377	′17B-	-10
S	Е	R	V	I	С	Е	Ν	0	Т	Е
377	717B PI	)H/SD	H/Jitter	Test	t Set		SUPERSEDES	S: NON	E	
Ser	ial Numbo	ers: N/A	A							
Opt	tions: Al	11								
Bui	ld Status:	2:23 to	2:69							
Ins	trument	: Fails t	to Downl	oad l	Firmware	e via∣	Floppy disk			
To	be Perfor	med by:	Qualified	Servic	ce Personne	el				
Par	ts Requir	ed:								
Des	cription	Р	art Numbe	er	Quantit	y B	uild Status Affec	eted		
	eened disk e Kit	- 3	7717-60190	)	1		2:23 to 2:40 (inc	c)		
	lated Wire	e			0.25	Metre	2:23 to 2:69(inc	)		
Situ	ation									
with		atus Nurr	nber in the a				are via disks on 3 nent Build Status			
									Continue	ed
							DATE: March	1997

## **MODIFICATION RECOMMENDED**

Figure 1 - Showing the Wire-Link modification to the Processor Board

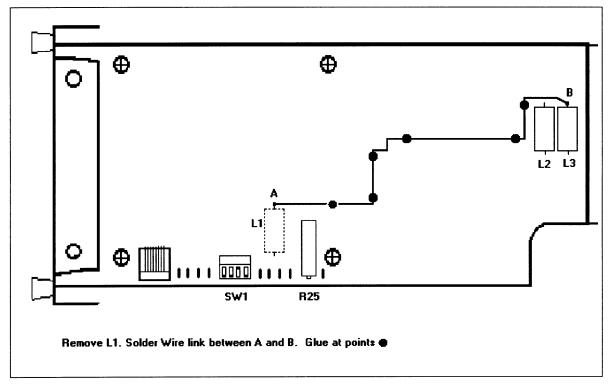
A wire-link modification to the processor PCB to improve the stability of the disk-drive supply voltage should also be done on these units. This modification was introduced at BS 2:69.

If any 37717B unit with Build Status between 2:23 and 2:69 (inclusive) is encountered, carry out the wire-link modification to the processor PCB as described below.

#### Adding the Wire-Link (See Figure 1)

Figure 2 Processor Module (viewed from top)

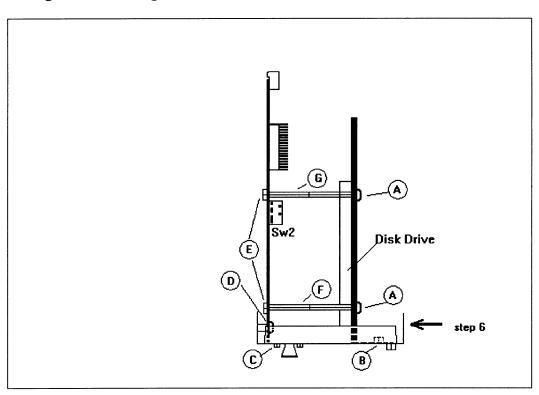
In addition, if the Build Status is between 2:23 and 2:40, order the special Screened disk-drive Assembly Kit and fit this by following the procedure below. This specially screened disk drive is more resistant to PSU generated RFI and will prevent the corruption of data which causes the downloading problem to occur.

The old disk-drive is replaced together with the processor front panel as this makes for easier dismantling and assembly procedures and removes the requirement for precision alignment.

- 1. Unscrew the four posidrive screws which secure the Disk Drive with it's metal shield to the disk-drive supports on the CPU Board (Figure 2 item A).
- 2. Unscrew the nut which secures the Disk Drive to the CPU module front panel (Figure 2 item B).

- 3. Unclip the GPIB and RS-232 ribbon cables from their sockets on the CPU board. Feed the GPIB ribbon cable out through the slot in the disk drive metal shield.
- 4. Unclip the disk-drive ribbon cable from it's socket on the CPU board and place the disk-drive and metal shield to one side in an anti-static bag.
- 5. Unscrew the two nuts which secure the PARALLEL Interface Connector to the module Front Panel (Figure 2 item C).
- 6. Using a long posidrive screwdriver, unscrew the two screws which secure the module Front Panel to the CPU Board (Figure 2 item D).
- 7. Remove the module Front Panel and place to one side.
- 8. Unscrew the nuts (Figure 2 item E) securing the four disk-drive supports to the CPU Board.Discard these supports (Figure 2 items F and G).
- 9. Fit the two new supports from the kit in the rear two support holes only (Figure 2 item G).

- 1. Clip the GPIB ribbon cable from the new Front Panel into it's socket on the CPU board.
- 2. Clip the new disk-drive ribbon cable into it's socket on the CPU board.
- 3. Align the CPU Board with the holes in the new front panel and secure using the original two screws.
- 4. Clip the RS232 ribbon cable from the new Front Panel into J2 socket on the CPU board.
- 5. Secure the new Disk Drive to the new rear disk-drive supports on the CPU Board using two of the original screws.
- 6. Replace the two nuts which secure the PARALLEL Interface Connector to the new Front Panel.

Figure 3 Position of Processor Module and Insertion Tool

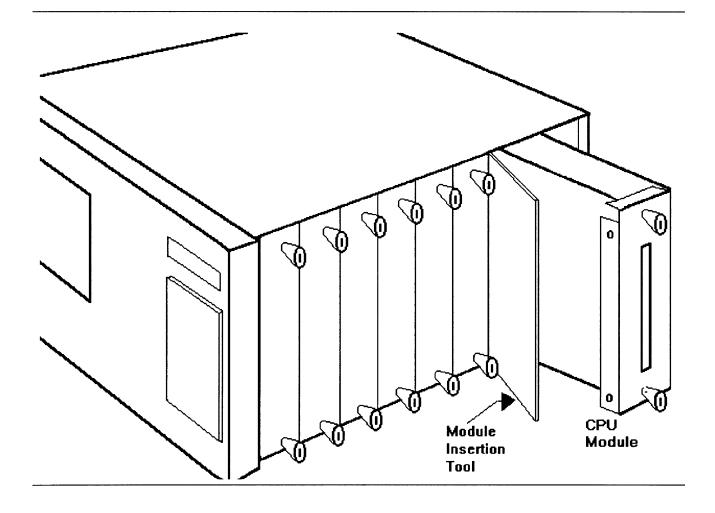
To prevent removal of, or damage to the metal RFI STRIP on the module next to the CPU, you MUST use special tool part number 03776-00016 or a thin LOW-STATIC plastic or fibre card (200mm x 135mm x 0.5mm) when inserting the CPU module back into the instrument. Place this card against the RFI Strip, then slide the CPU Module back into the instrument. Push the CPU Module fully home, then pull out the card - see Figure 3.
